Council Reference: DA04/0162.03

TSC Response to TCA Letters June and July 2018 – Compliance & Modification DA04/0162.03 - amendment to Development Consent DA04/0162 for expansion and amalgamation of existing quarries at Lot 28 DP 1079480 Pollards Road Dulguigan

Attachment 1 – TSC - Table - Extraction Volume Calculations & Trips **Tumbulgum Community Association letter of 12 June 2018**

The development is outlined at page 6 of the Statement of Environmental Effects by Jim Glazebrook and Associates in February 2004. Scanned extract follows.

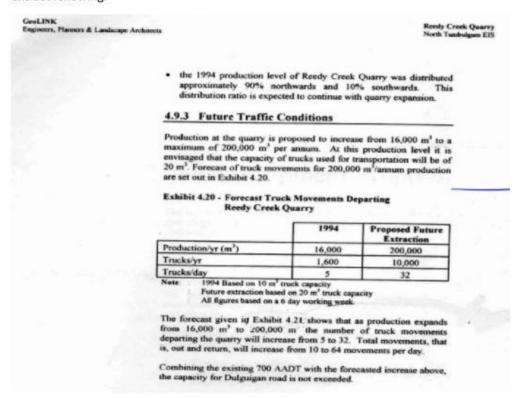
This proposal sequentially lists in the first three (3) bullet points the extraction amount followed by operating hours and days/half day of operation then followed by allowable numbers of truck movements. Reading down of this document clearly implies the linkage between operating days and truck movements.

Although the latter letter from Jim Glazebrook and Associates of 8 October 2004 misrepresents the Development Consent 98/178 by replacing maximum number of trucks with average per day, it does **NOT** remove the relationship between operating days and truck activity. Trucks cannot enter or leave the quarry on non-working days.

Council understands the Tumbulgum Community Associations position, however the conditions of DA04/0162 are considered to prevail over all past documenttaion which

Council are of the view that these two documents read in conjunction with one another and prevail over the historic EIS interpretation.

Based on these documents the quarry appears to be able to have 14,600 truckloads of material leave the site in any given year.
